THQ

Proposed Amendments to LPA Ref. 121270/00/2018

THG1(REP)A005_C

Airport City Manchester

Proposals December 2021

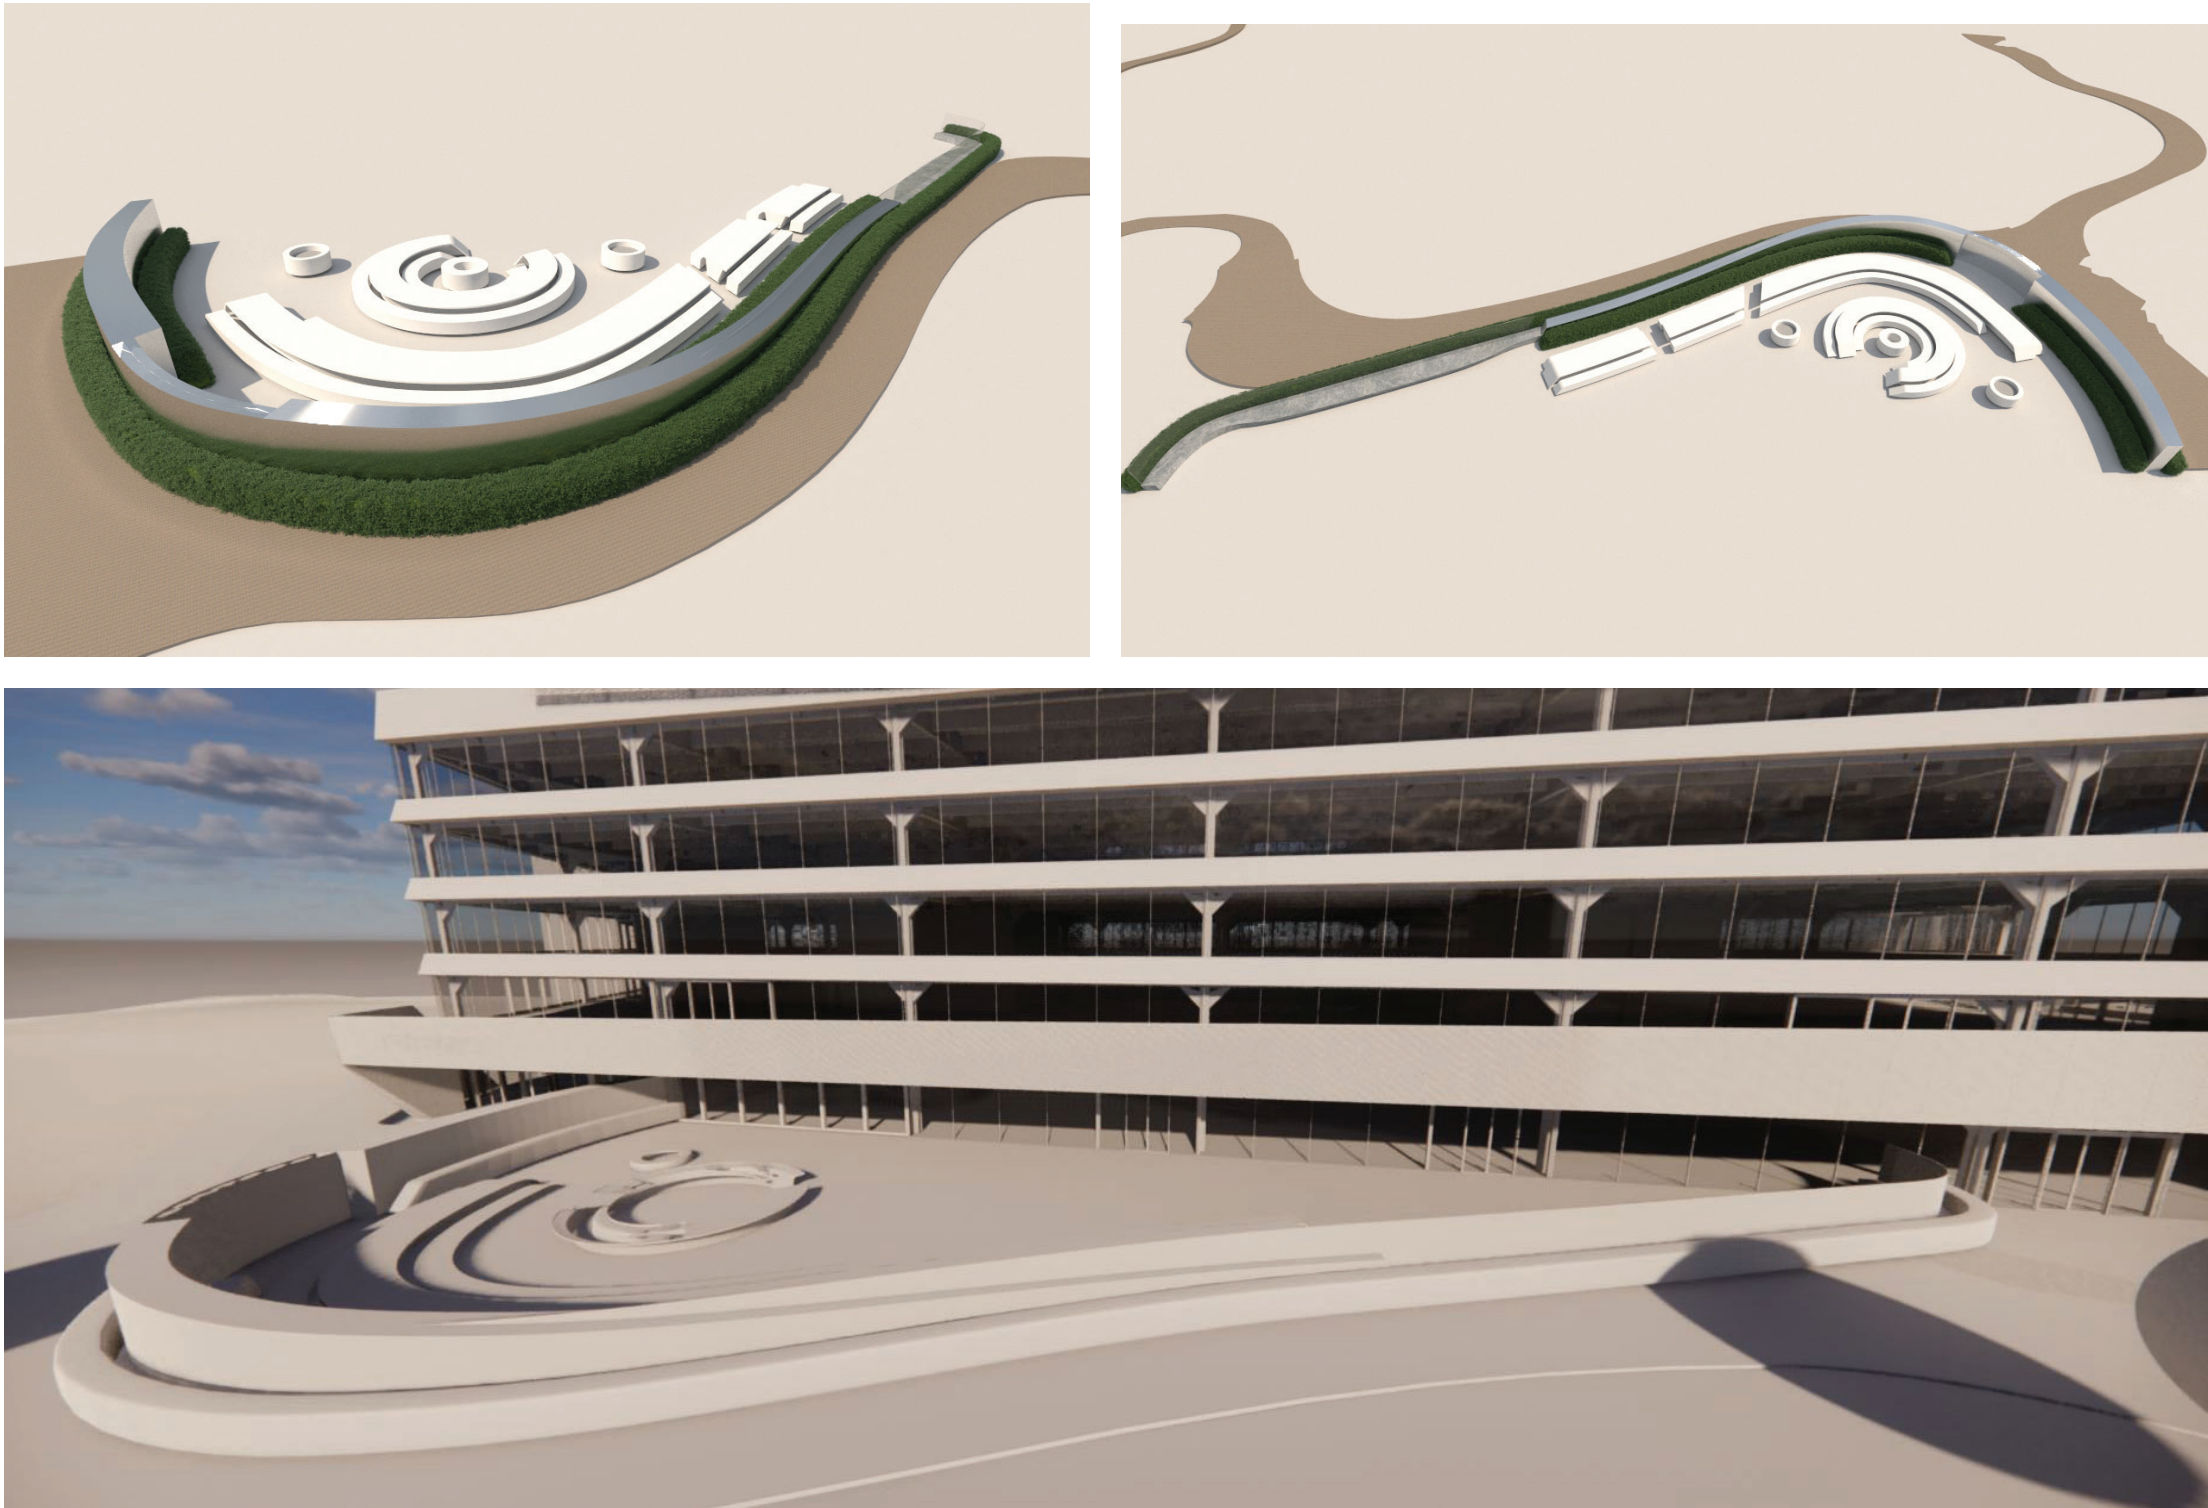
Changes to landscape

1. THG garden boundary amended. Hedge shape updated to reflect the updated THG garden boundary.
2. Removal of concierge drop off point canopy.
